American Telecommunications Certification Body Inc.
6731 Whittier Ave, McLean, VA 22101

RE: FCC ID: Q7Z-MA720R1_ATCB002413
Attention: Vincent Su

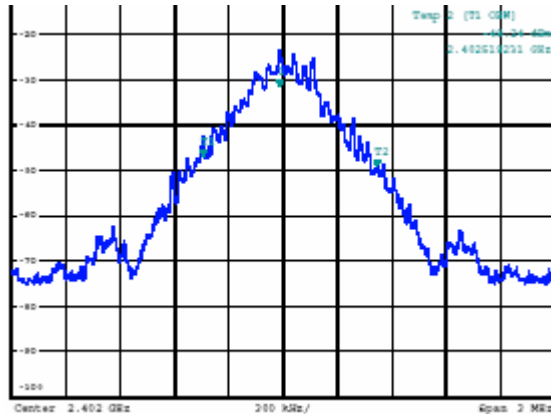
1. The manual on the above device does not appear to contain the required non-modification statement per 15.21 nor the users info statement per 15.105.
2. Please note that the test setup photos appear to show the device on the table and not connected to the USB port. As this device derives power from the USB port, please show the device being tested while installed in the USB port. IF the device is installed in the USB port, please point to the device in the photos or take a close up photo of the device.
3. Please note that the 20dB band width plots on page 19 do not look like a typical Bluetooth device and there is no resemblance to the wave shape shown in the separation plots (i.e. no 26+dB spike at the center frequency). Please note that the 20dB bandwidth of a BT device should be approximately 650kHz to 850kHz as follows:

The data in the plots in the report provided show an unusually high spike (26+dB) at the center frequency. This indicates the device is not functioning properly or an error in measurement setup has occurred. Please explain. Please provide 20dB bandwidth plots that are in line with that expected of a BT device.
